PLANNING COMMISSION MEETING AGENDA SPECIAL/STUDY MEETING

SUBJECT: PUBLIC HEARING – CONDITIONAL REZONING APPLICATION (File Number CR 009) – Proposed Troy Marriott Hotels, West side of Stephenson Highway, North of 14 Mile (333 Stephenson Highway), Section 35, From O (Office) District to OM (Office Mixed Use) District

Conditional Rezoning, Site Plan Review, and Special Use For City of Troy, Michigan

Applicant	Akram Namou, A&M Hospitality
Project Name:	Troy Marriott Hotels
Plan Date:	August 9, 2013
Location:	333 Stephenson Hwy between 14 Mile and E. Maple
Zoning:	O, Office Building District
Action Requested:	Conditional Rezoning Request to OM, Office Mixed Use; Site Plan Approval, and Special Use Approval
Required Information:	Deficiencies noted.

SITE PLAN

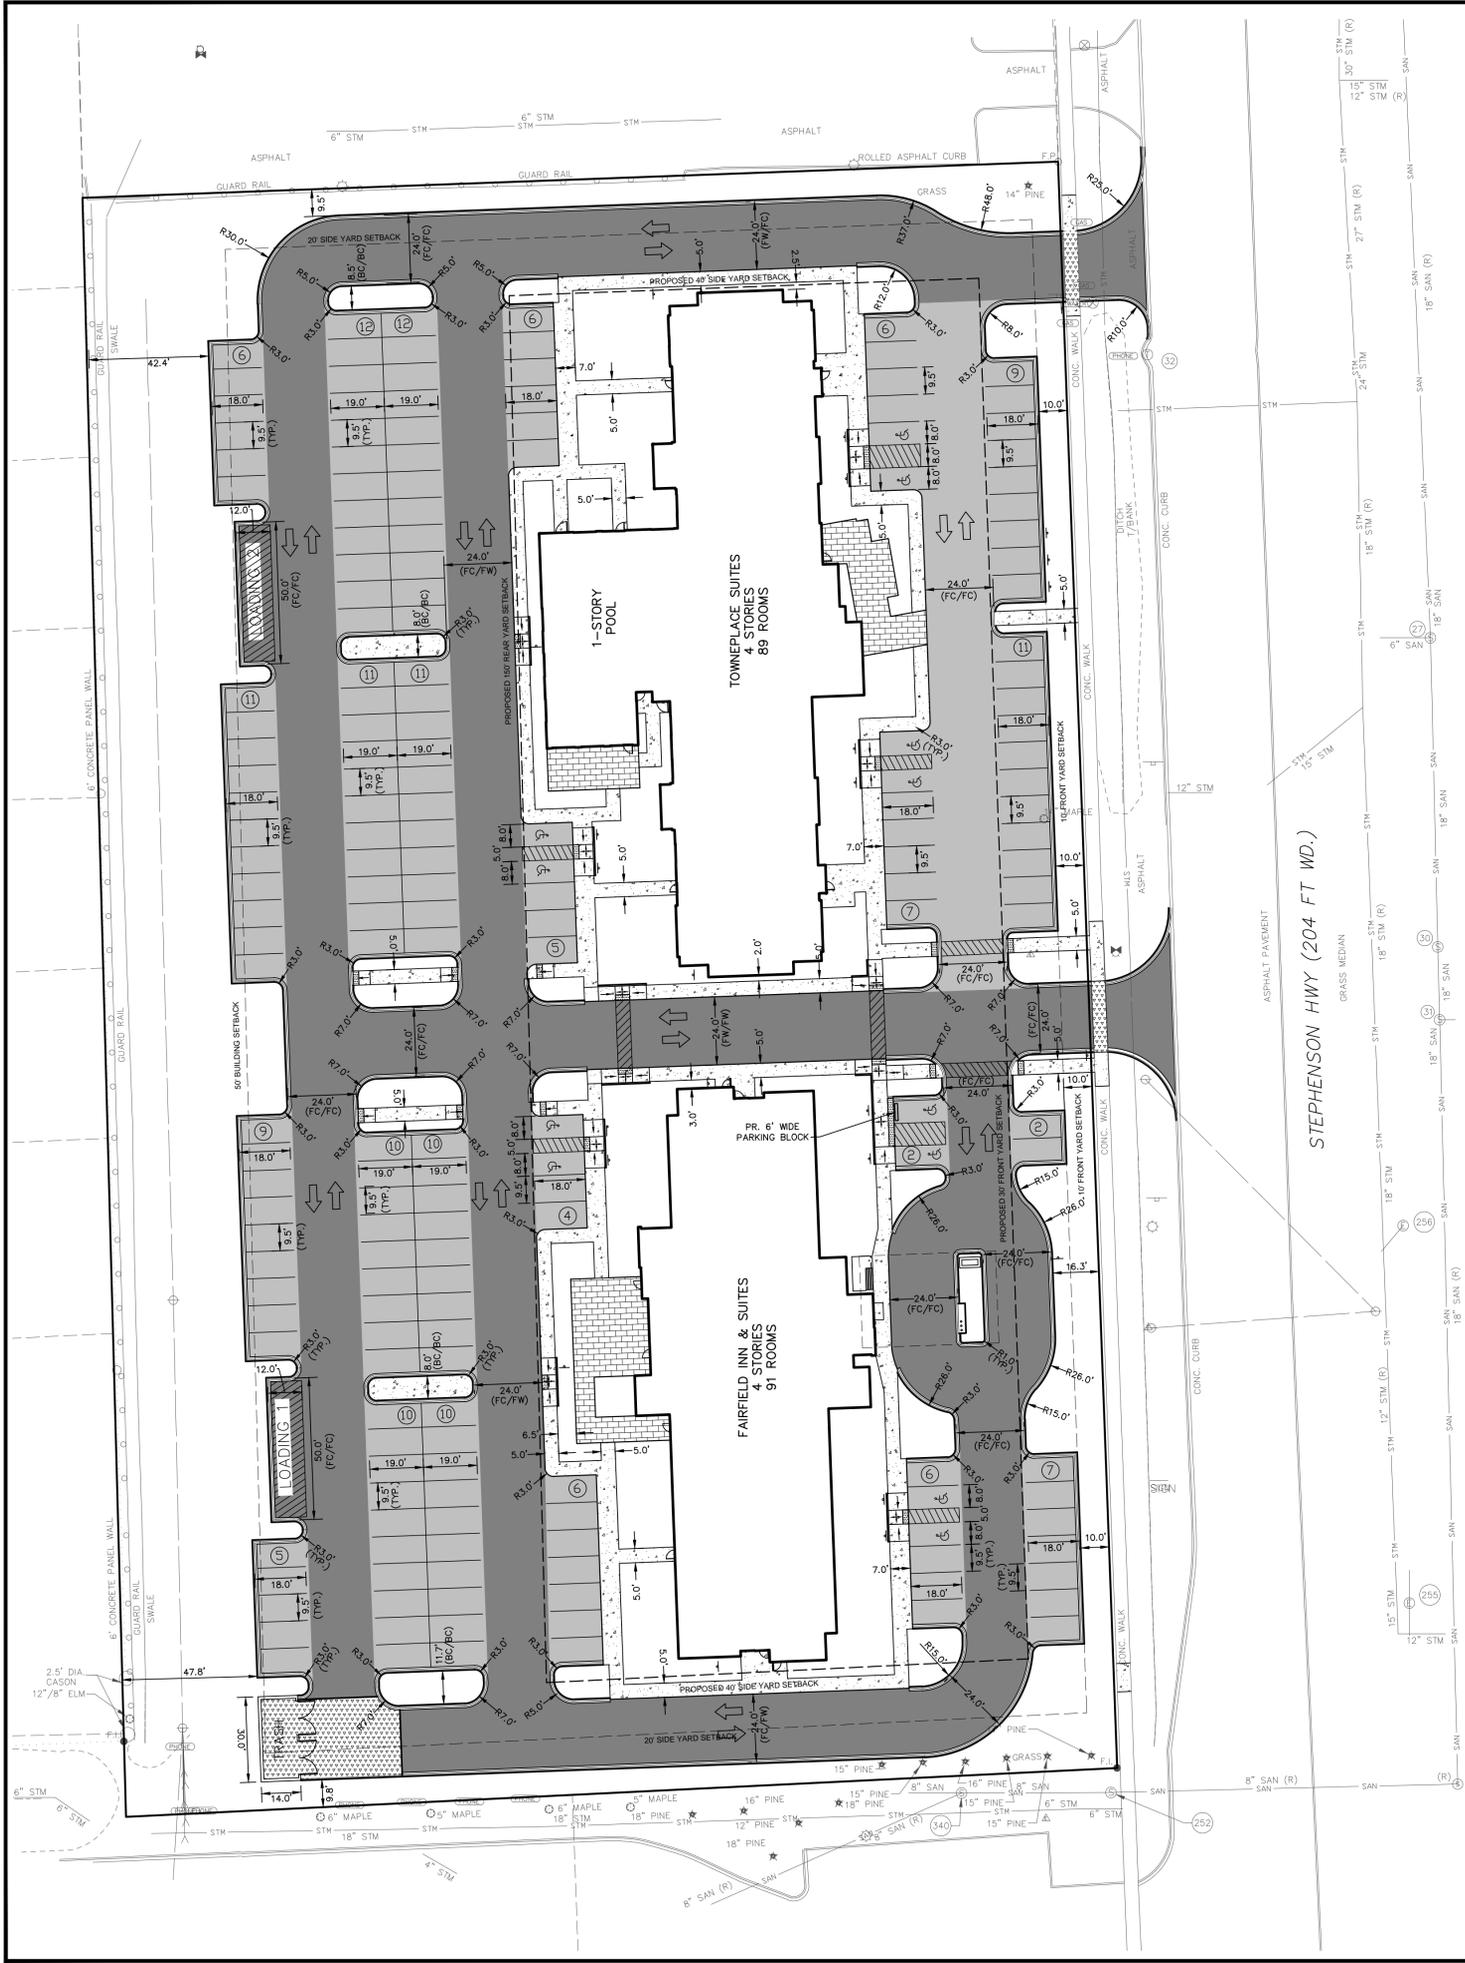
In the detailed site plan the applicant has moved the building further away from the rear property lines; however there are additional site arrangements should be considered to mitigate impacts on adjacent properties. Additional considerations in regards to site arrangements include:

- Turn the buildings so that the short side is parallel to the residential properties. Doing this would reduce the total amount of windows that face residential properties and allow the drop off, and most of the parking and activity to occur between the buildings rather than in the rear. Conversely, it would push the rear of the buildings closer to the rear of the property.
- Reduce/remove parking in front of the buildings so that the buildings can be moved up closer to Stephenson Highway. The minimum setback along Stephenson Highway is 10-feet.
- Alter the floor plans so that the mechanical/utilities/stairway is located along the rear elevation. Moving these facilities along the rear elevation would allow the applicant to reduce the number of windows.

Trash Enclosure: The applicant has located one trash enclosure for the facility as the southwest corner of the site. The applicant added a note on the site plan that the trash enclosure will be made of 6' high poured concrete. However, no information regarding color, or gate details was provided. Additional trash enclosure details should be provided.

LANDSCAPE PLAN
TROY MARIOTT HOTELS
CITY OF TROY
OAKLAND COUNTY
MICHIGAN

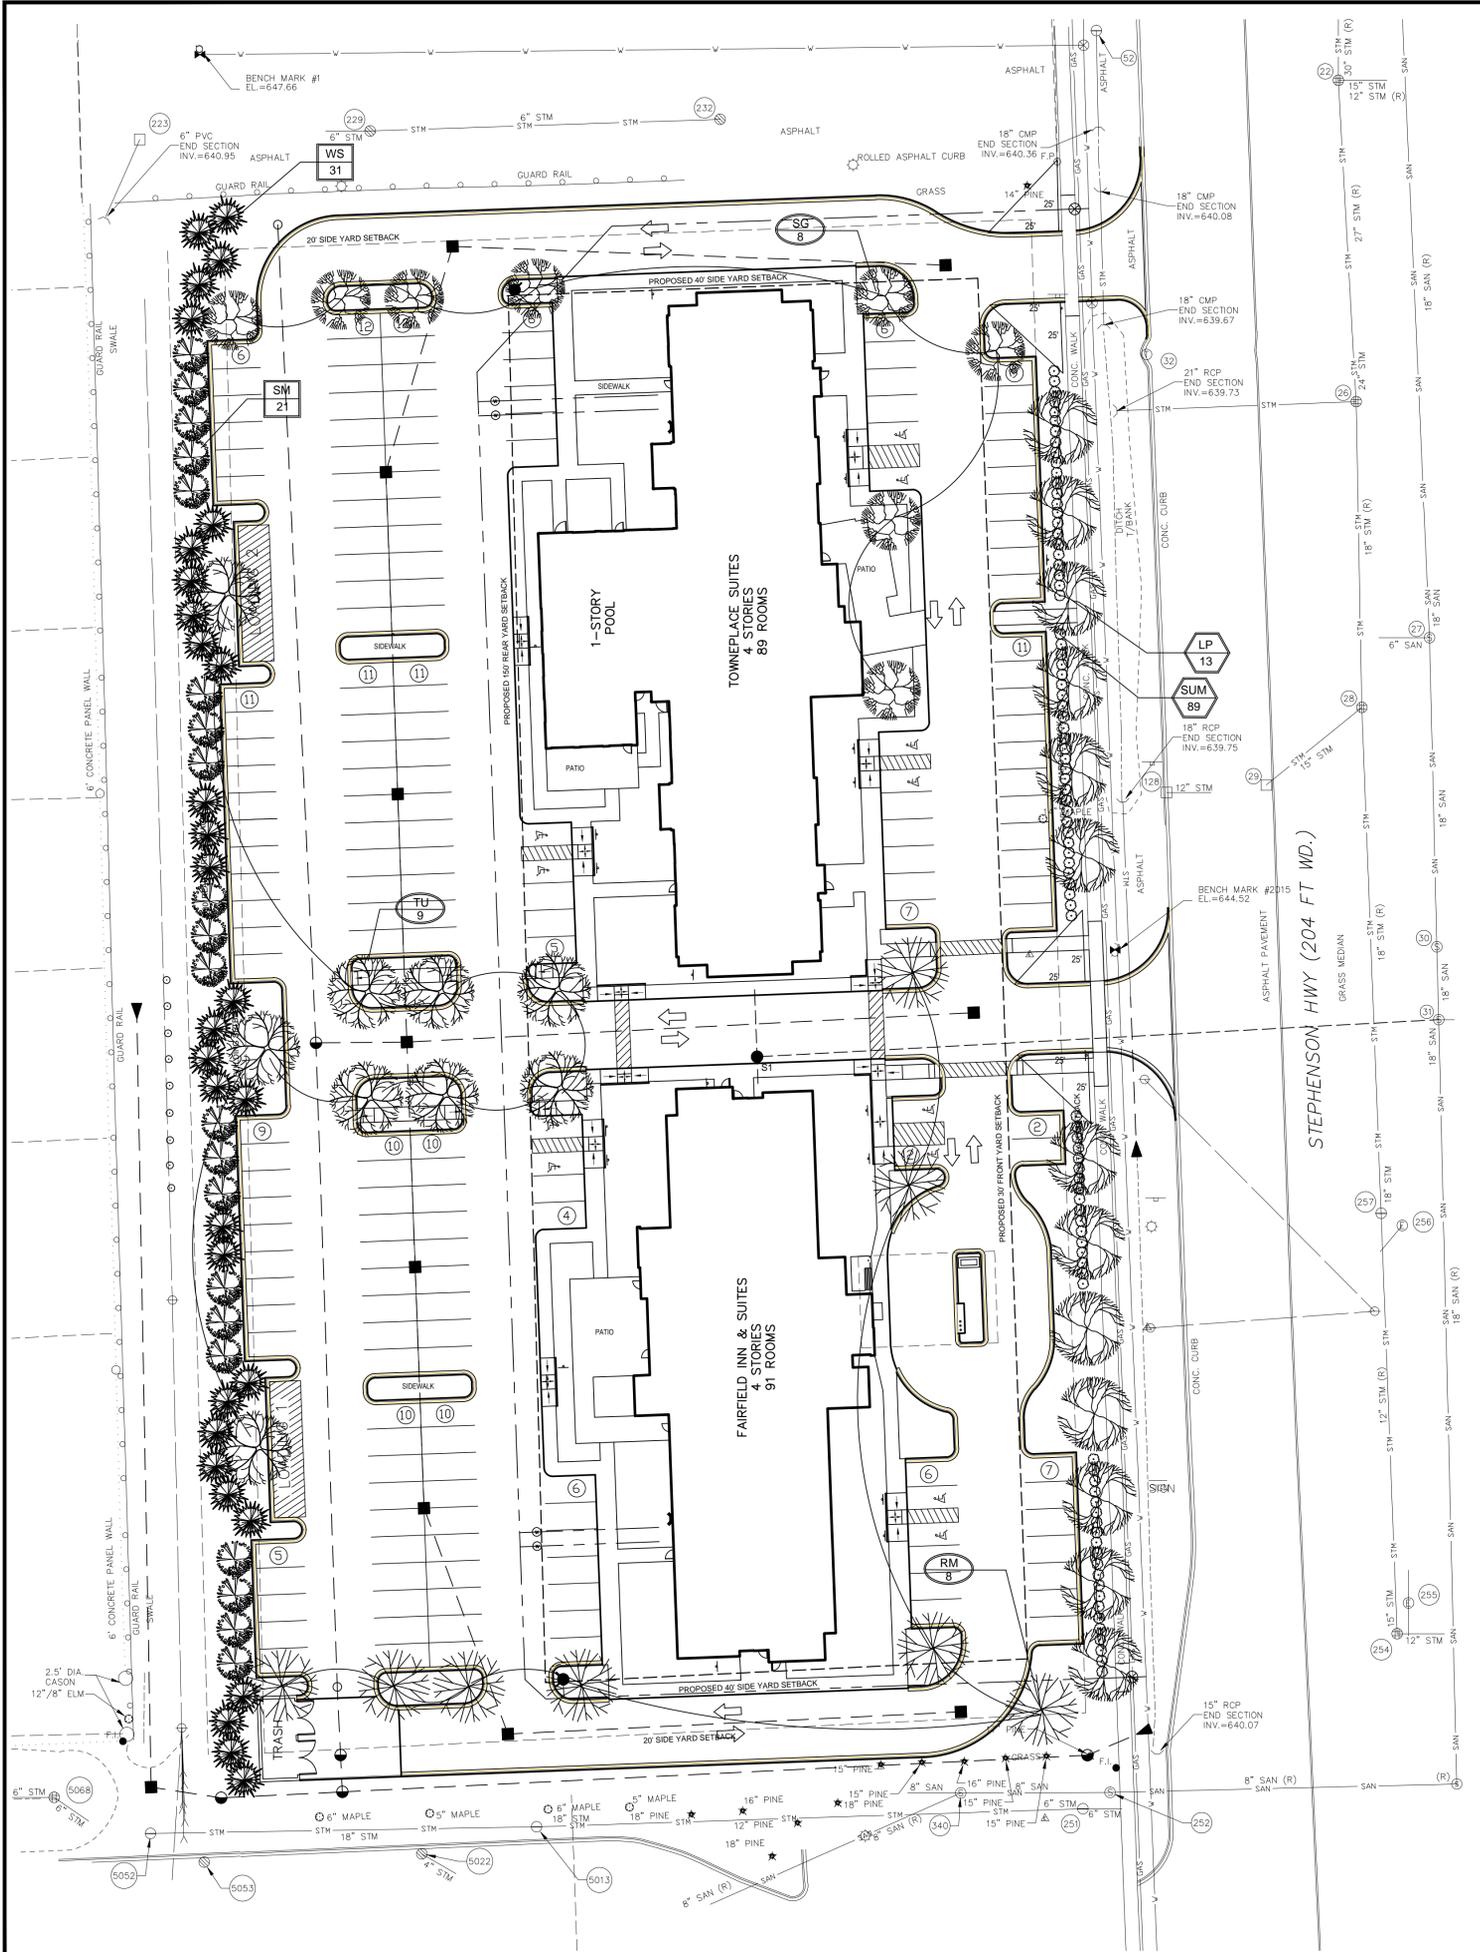
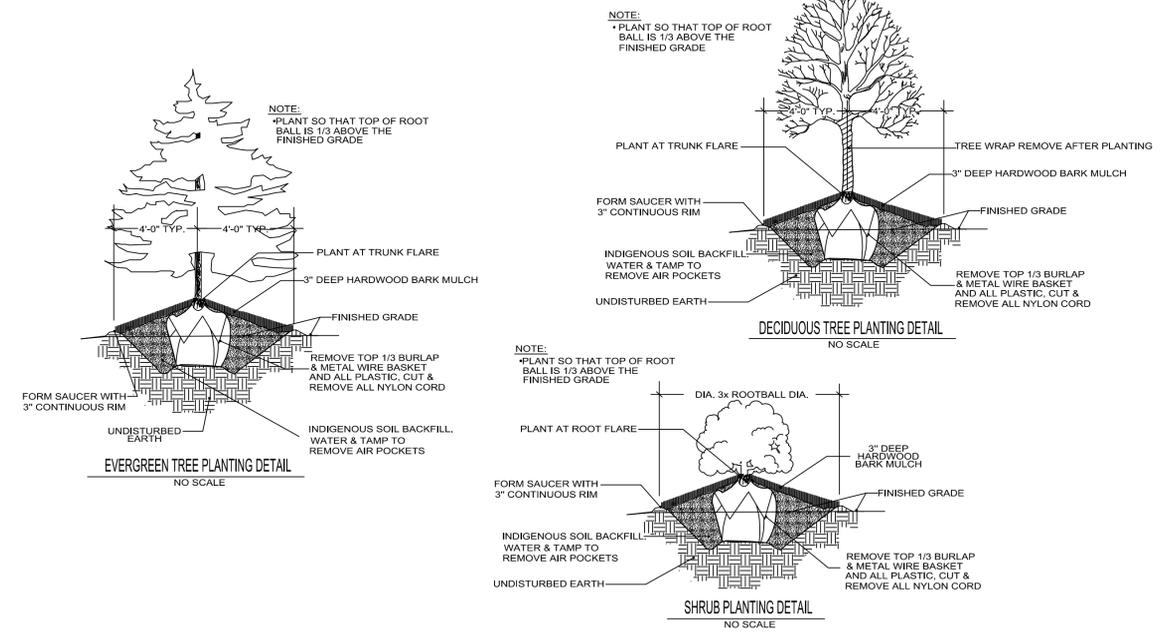
The applicant should provide landscape calculation figure. The applicant proposes additional rear yard landscape screening which includes 31 white spruce and 21 sugar maple. The white spruce are 12 to 15-feet height at time of planting and the 3 to 4-inch sugar maples are 12 to 15-feet in height at time of planting.

Items to be Addressed: 1). Provide landscape percentage calculation; 2). Replace existing 6-foot concrete wall with an 8-foot decorative sound wall; and 3). Provide additional trash enclosure screening details.

SIGHTLINE PROFILE
PLAN
SECTION A-A

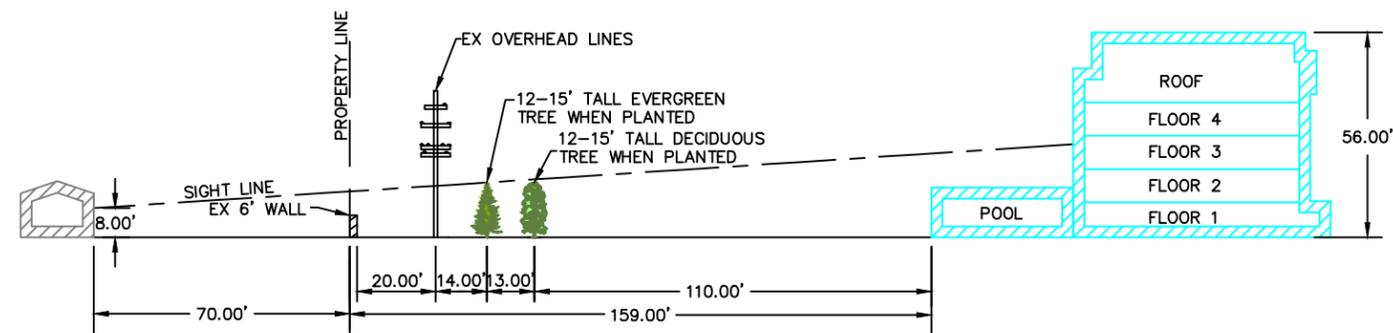
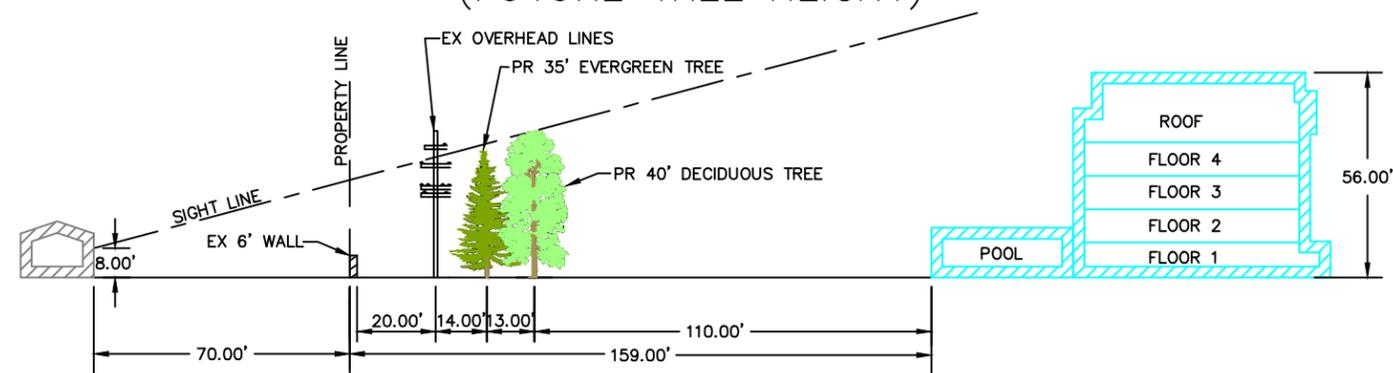
Mr. Wakeland addressed their efforts to mitigate the potential impact to adjacent residential as relates to the proposed setbacks and screening. Mr. Wakeland provided a sight line profile from the proposed four-story hotel to adjacent residential.

The Board asked if the petitioner would provide additional screening details, precise setbacks, sight-line information and consideration to various building configurations to mitigate the concerns expressed by adjacent residential.

Drawing No.
#13-17400-V1-LED

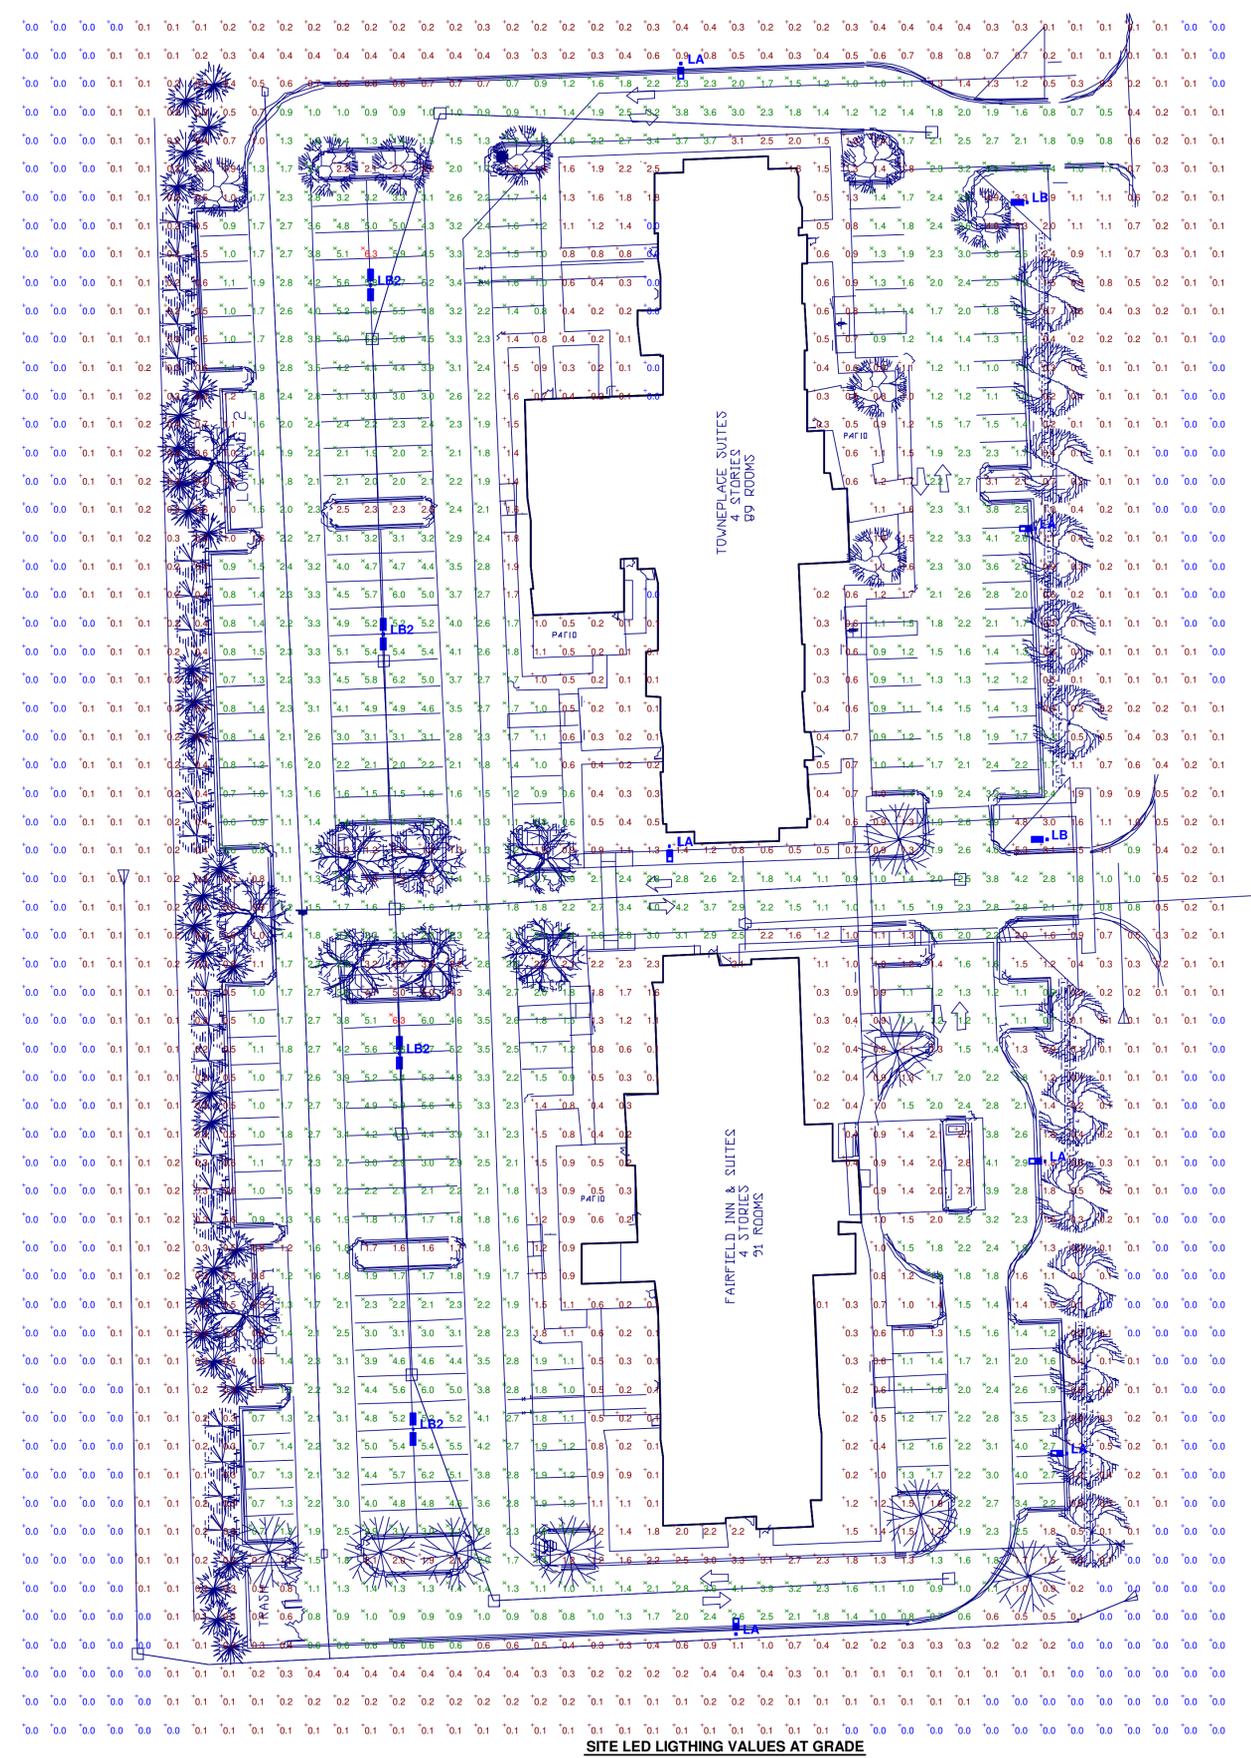
The applicant does not indicate any building lights. The building code requires lighting for each exterior door. The applicant should confirm that they are not proposing any building lighting above the first floor. Any building lights should be shown on the elevation, included in the photometric calculations, and have a submitted cut sheet.

Items to be Addressed: 1). Reduce pole height to a maximum of 15-feet; 2). Relocate poles in rear parking area to curbed landscape area; 3). Confirm that there is no building lighting above the first floor; and 4). Show building lighting on the elevation, include in the photometric calculations, and submit a cut sheet.
